UNITED STATES
DEPARTMENT OF THE INTERIOR
BUREAU OF LAND MANAGEMENTFORM APPROVED
OMB NO. 1004-0137
Expires: January 31, 2018**SUNDRY NOTICES AND REPORTS ON WELLS**
*Do not use this form for proposals to drill or to re-enter an abandoned well. Use form 3160-3 (APD) for such proposals.*5. Lease Serial No.
NMNM94651

☒ Oil Well ☐ Gas Well ☐ Other2. Name of Operator
OXY USA INCORPORATEDContact: DAVID STEWART
E-Mail: david_stewart@oxy.com8. Well Name and No.
CEDAR CANYON 20 FEDERAL COM 24H9. API Well No.
30-015-44545-00-S13a. Address
5 GREENWAY PLAZA SUITE 110
HOUSTON, TX 77046-0521

OXY USA Inc. respectfully requests approval for the following changes from the approved permit:

WELL LOCATION AND ACREAGE DEDICATION PLAT

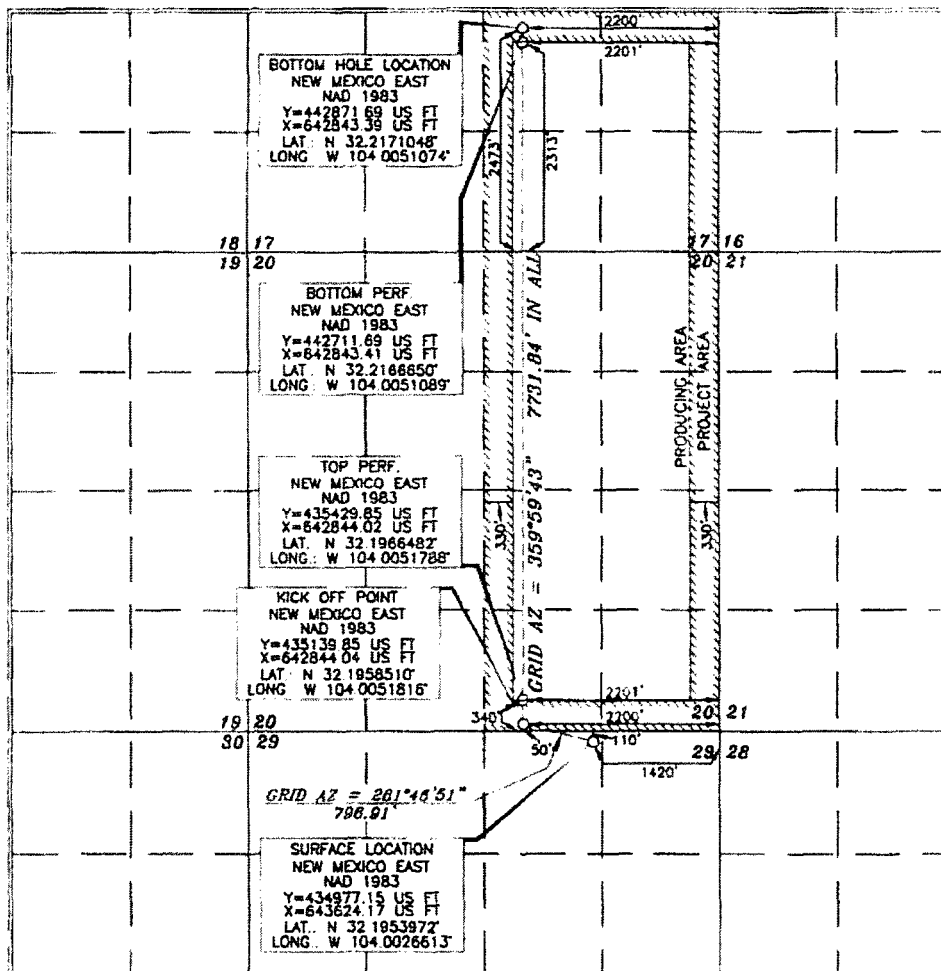
1. The horizontal lateral will increase to ~7500', amended C-102, directional plan and plot attached.

Surface ? 110 FNL 1420 FEL NWNE 29-24S 29E - Lat. 32.1953972 Long. 104.0026613
KOP ? 50 FSL 2200 FEL SWSE 20-24S 29E - Lat. 32.195851 Long. 104.0051816
PPP ? 340 FSL 2201 FEL SWSE 20-24S-29E ? Lat. 32.1966482 Long. 104.0051788
Amd Exit ? 2313 FSL 2201 FEL NWSE 17-24S-29E ? Lat. 32.216665 Long. 104.0051089
Amd BHL ? 2473 FSL 2200 FEL NWSE 17-24S-29E ? Lat. 32.2171048 Long. 104.0051074

13" 5K MBS SL2 Wellhead

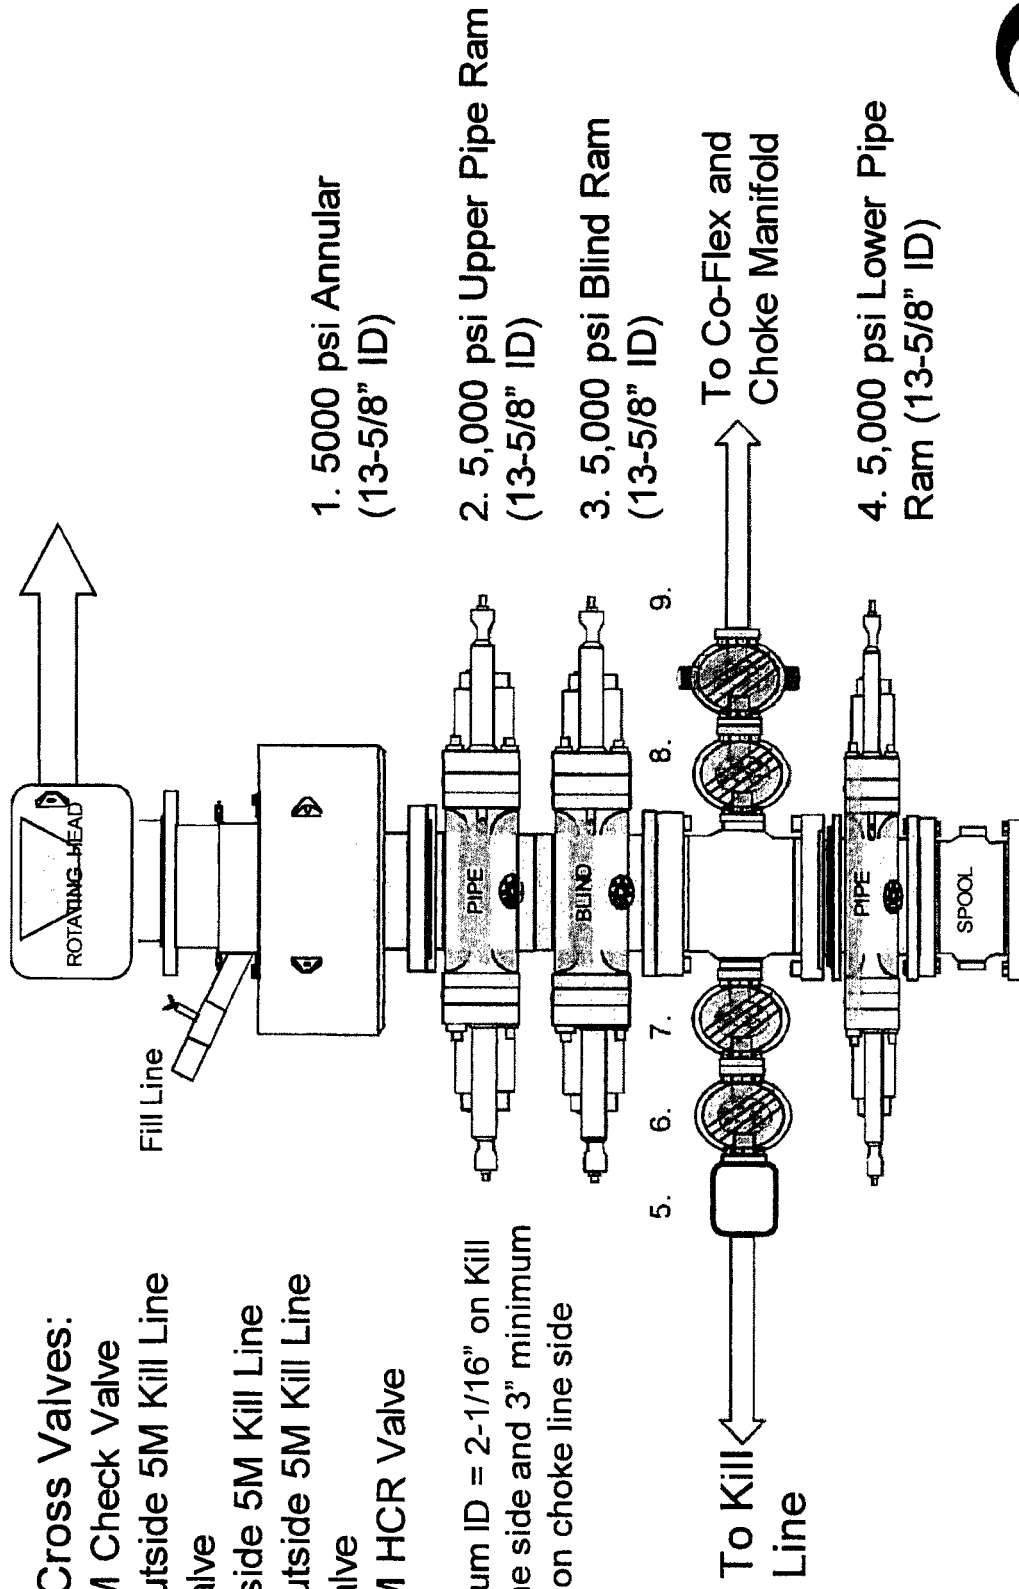
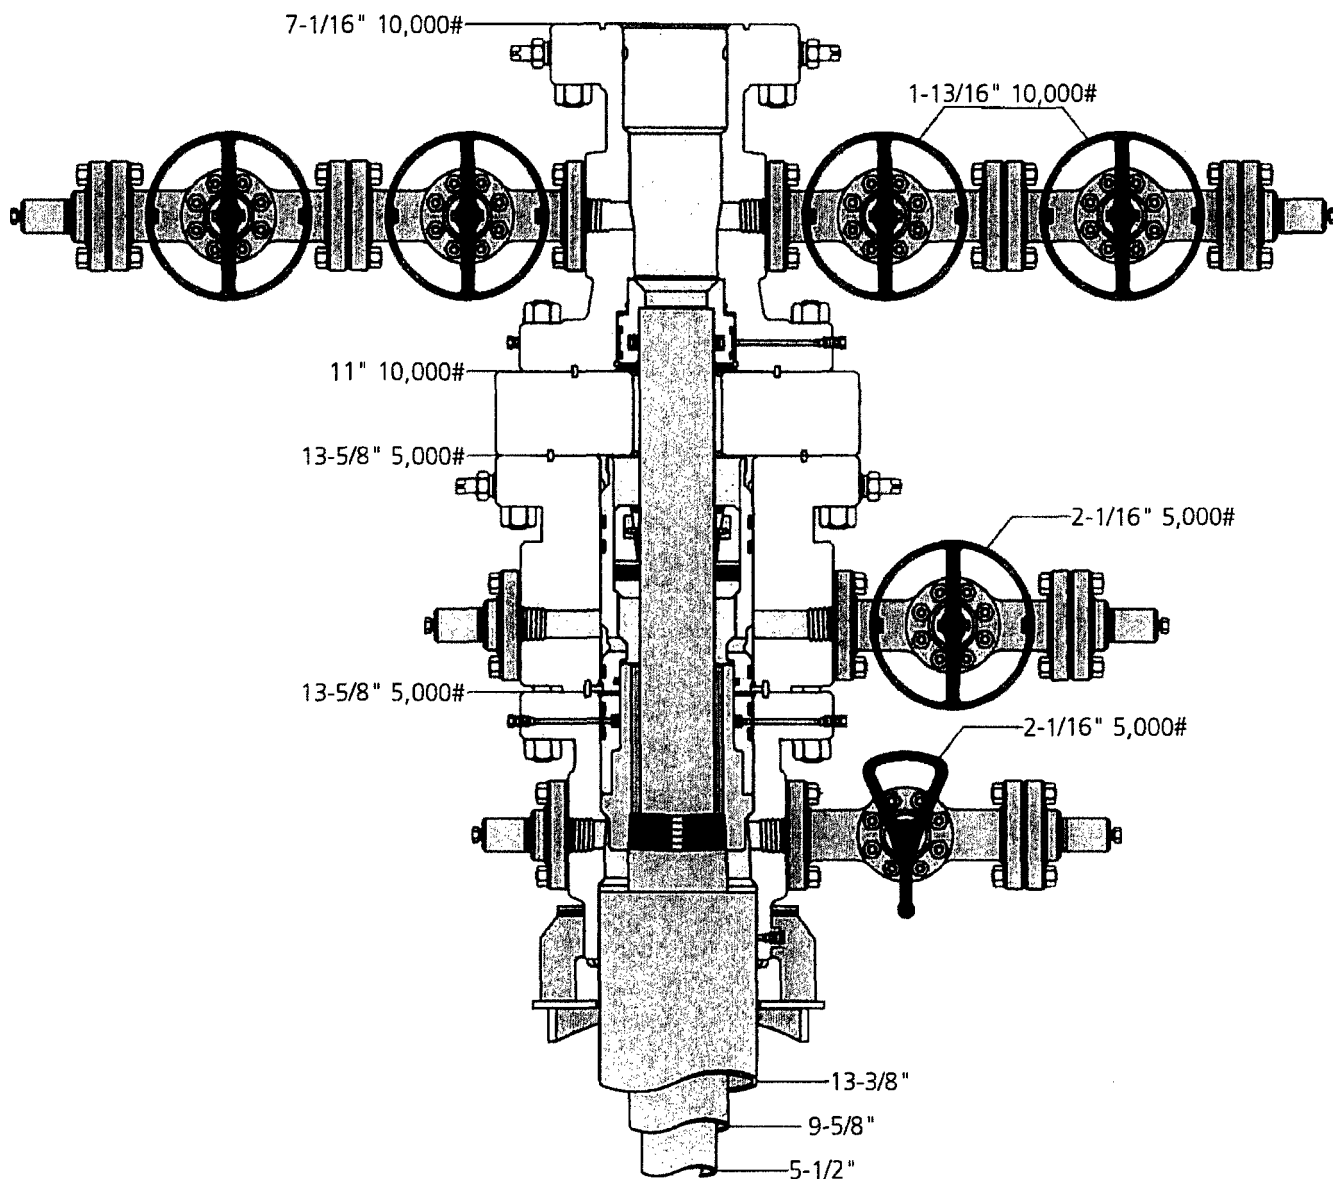
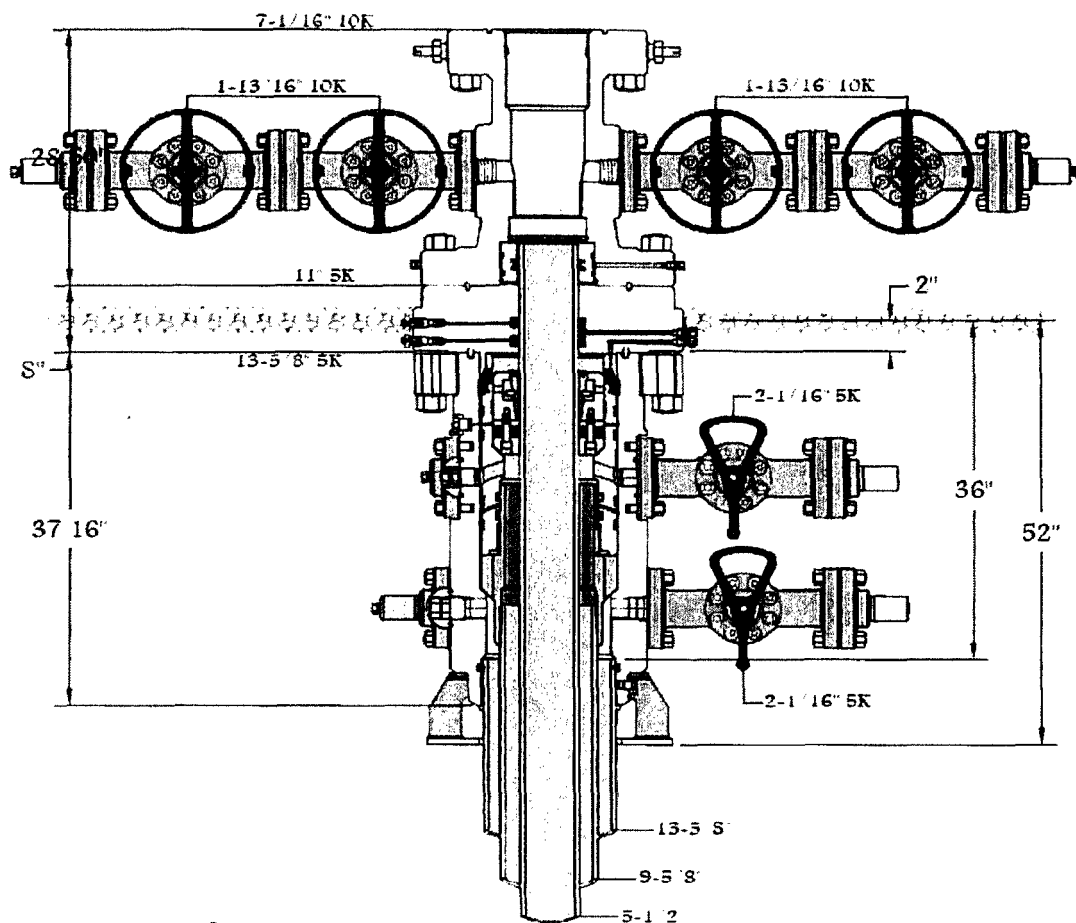
2. A multibowl or a unionized multibowl wellhead system will be employed. The wellhead and connection to the BOPE will meet all API 6A requirements. See attached for amended BOP diagrams.

| A multibowl or a unionized multibowl wellhead system will be employed. The wellhead and connection to the BOPE will meet all API 6A requirements. The BOP will be tested per Onshore Order #2 after installation on the surface casing which will cover testing requirements for a maximum of 30 days. If any seal subject to test pressure is broken the system must be tested. We will test the flange connection of the wellhead with a test port that is directly in the flange. We are proposing that we will run the wellhead through the rotary prior to cementing surface casing as discussed with the BLM on October 8, 2015. See attached schematics. | |
